FAA POLICY STATEMENT – CLARIFICATIONS AND ADDITIONS FOR FUTURE ADVISORY CIRCULAR

March 16, 2016

Policy No: PS-ANM-25.853-01

Definition - PS 9 Color of Thermoplastics, .. - Integrally Colored

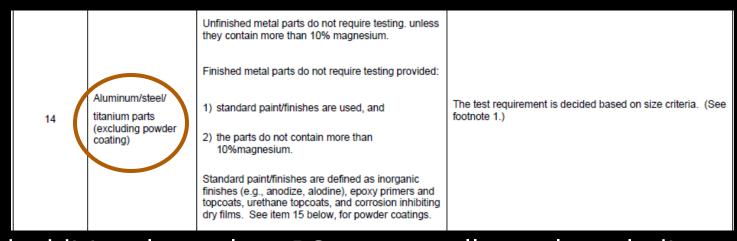
• Integrally Colored is defined by the color of the material being the same throughout the material (given some variance due to fillers and process effects). For example, thermoplastics tend to be integrally colored or pigmented, while decorative laminates tend to be printed on a single surface.
